MIDLAND ENERGY CENTER PROJECT
MIDLAND DOCKET NOS 50-329, 50-330
AUXILIARY FEEDWATER LEVEL CONTROL VALVES
FILE B7.9, B10.4.9 SERIAL 21623

MIDLAND PLANT UNITS 1 & 2
CONSUMERS POWER COMPANY

LOGIC DIAGRAM
STEAM GENERATOR AID, FW
LEVEL CONTROL VALVE

BECHTEL ANN ARBOR, MICHIGAN		
MIDLAND PLANT UNITS 1 & 2 CONSUMERS POWER COMPANY		
SCHEMATIC DIAGRAM AUXILIARY FEEDWATER SYSTEM VALVES		
	JCS NO. 7220	DRAWING NO. E-158(1) SH.54
	REV. 4

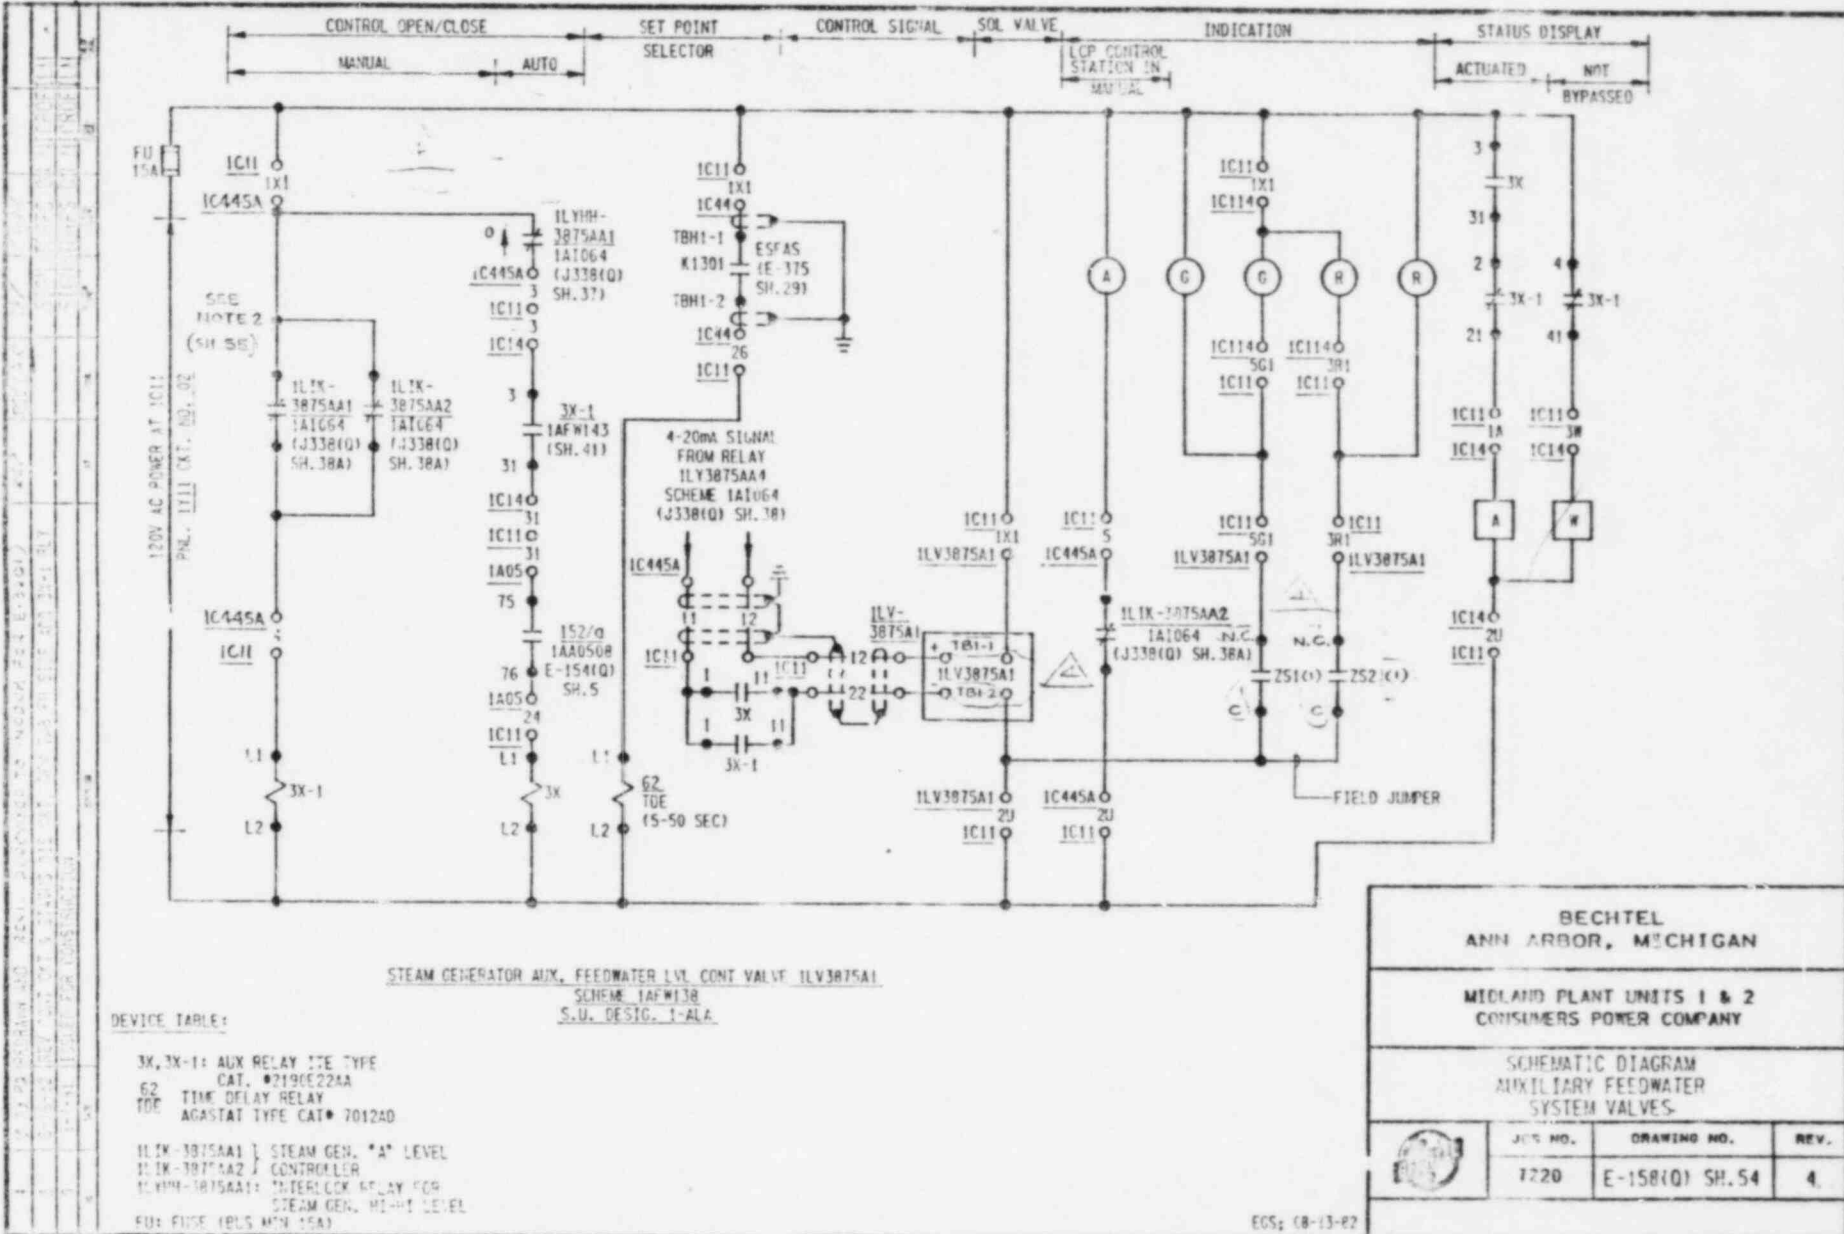
SER Confirmatory Item (20) discusses Consumers Power's commitment to modify the design of the auxiliary feedwater level control valves to ensure that these valves will continue to receive a modulating signal even if the AFW actuation signal is reset. This modification has been completed and FSAR Section 7.4.1.1.3.2 has been updated in Revision 47 to describe the modified level control valve actuating circuit. Attached to this letter are Sheets 1 and 2 of Logic Diagram J-261 and Sheets 54 and 58 of Electrical Schematics E-158 which show the modified circuitry. The level control valves on the motor driven AFW pumps have been modified to begin modulating when the pump breaker is closed, while the level control valves on the turbine driven pump have been modified to begin modulating when turbine control oil pressure is available. This method of providing the modulate signal to the level control valves will not be interrupted in the event the AFW actuate signal is blocked.
